REMARKS/ARGUMENTS

AMENDMENT TO THE DRAWINGS

FIG. 4

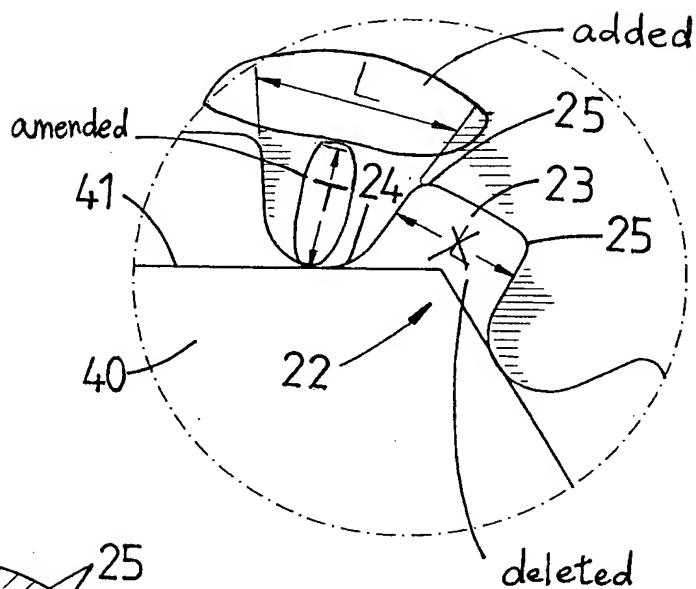
The Examiner stated that the specification and claims define "L" as the distance between the corner of each receiving recess and the corner of an adjacent receiving recess, but the drawings define "L" as the distance between the corners of a receiving recess. Consequently, it is not clear where the distance "L" lies. Additionally, since the corners of the receiving recesses are curved, it is not clear as to beginning and ending points of the distance "L". In addition, it is not clear how an increased depth "T" provides a larger contact area.

Responsive to this, figure 4 is corrected to match the specification and claims. In addition, figure 4 is also corrected to show beginning and ending points of the distance "L". In addition, the specification is amended in accordance with the Examiner's instruction to explain how an increased depth "T" (radius of curvature)

Replacement sheet of drawings are enclosed for the Examiner's approval. The attached sheet of drawings include changes to Fig. 4. This sheet, which includes Figs. 3 and 4, replaces the original sheet including Figs. 3 and 4. In figure 4, the position of the distance "L" has been corrected.
